To: Development Permit Panel
From: Joe Erceg
Manager, Development Applications
Date: July 11, 2003
File: DP 03-223156
Re: **Application by Paul Leong Architect Inc. for a Development Permit at
7360 Heather Street**

Staff Report

DRAWING TITLE
SITE PLAN
1

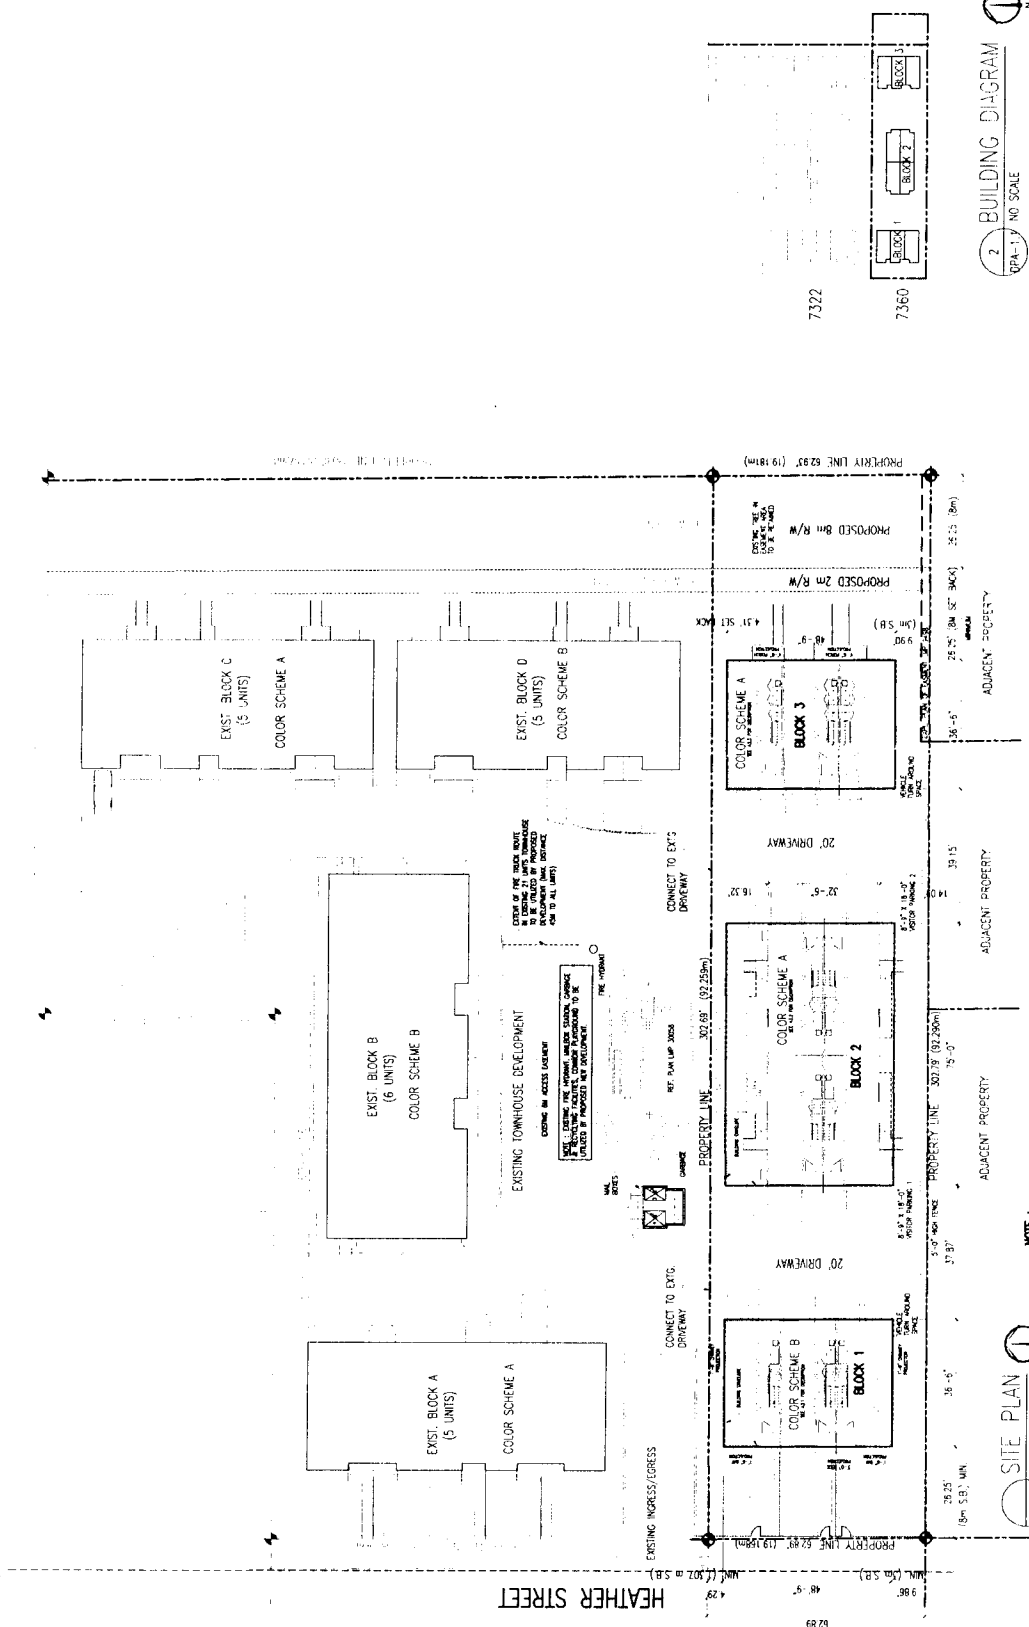
1. Allow the construction of 10 townhouse units on a property zoned Comprehensive Development District (CD/130); and that would:
2. Vary the regulations in the *Zoning and Development Bylaw* to:
 - reduce the side yard setback on the north side for two buildings from 3 m (9.843 ft.) to 1.29 m (4.25 ft.), and
 - reduce the setback from the east right-of-way from 6m (19.685') to 1m (3.28') for entry stairs.

A variance is required to allow two (2) of the buildings to be moved closer to the north property line. In addition, because of the 2m right-of-way on the east side, a variance is required for the entry stairs. The variances have minimal impact on the townhouses to the north since the relationship is side-yard to side-yard, similar to a single-family situation. Similarly, there is no significant impact on the east side, because it is a future road allowance.

Sheet 1 of 9
Landscape
Plan

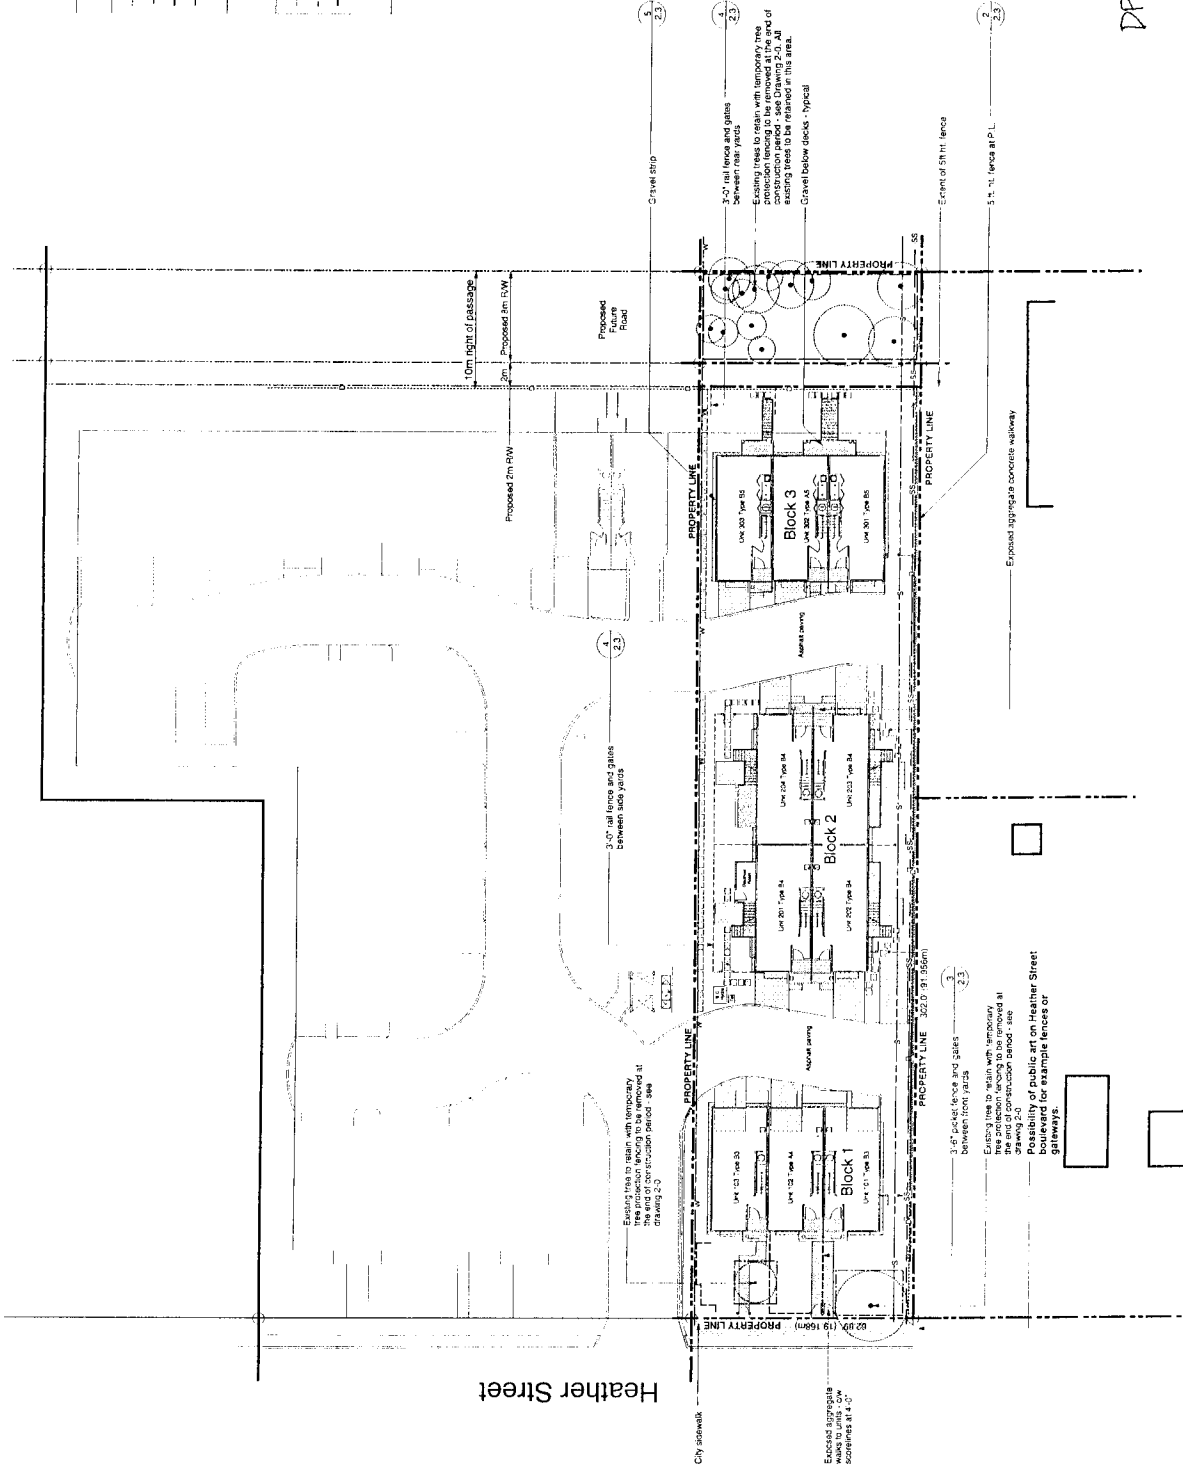
We confirmed that all but two (2) of the trees on the site were removed prior to the Development Permit application, which is contrary to City policy. The Official Community Plan (OCP) Development Permit Guidelines require 58 large calliper replacement trees two (2) for every one (1) cut. The remaining two (2) trees should be fenced as soon as possible. ***We note that the replacement trees are now shown on the landscape plans.***

At the December 16, 2002 Public Hearing, tree removal on this site and privacy/screening along the south boundary for the lots fronting General Currie Road became an issue. Via the Development Permit, Joe Erceg, Manager of Development Applications, has asked that staff ensure that the developer installs a screen fence, reviews potential overlook from south facing windows and plants appropriately located trees and shrubs for privacy. See December 16, 2002 Public Hearing Minutes for further details. ***Plans now indicate 18 Thuja plicata "Excelsia" at 3.5 m height along the south property line along with a 10 cm Norway Maple and other landscaping.***

BLOCK I
EXTERIOR ELEVATIONS
#6

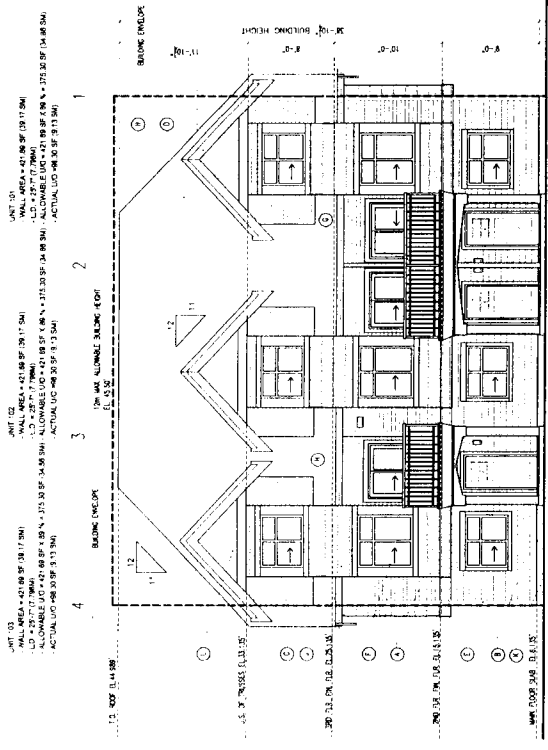
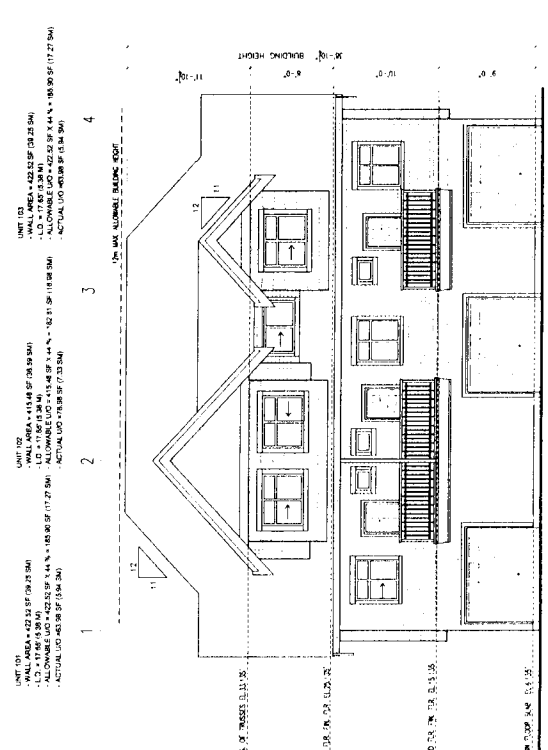
The two (2) colour schemes are a plus, and should be annotated on the drawings. ***The colours are now shown on the plans.***
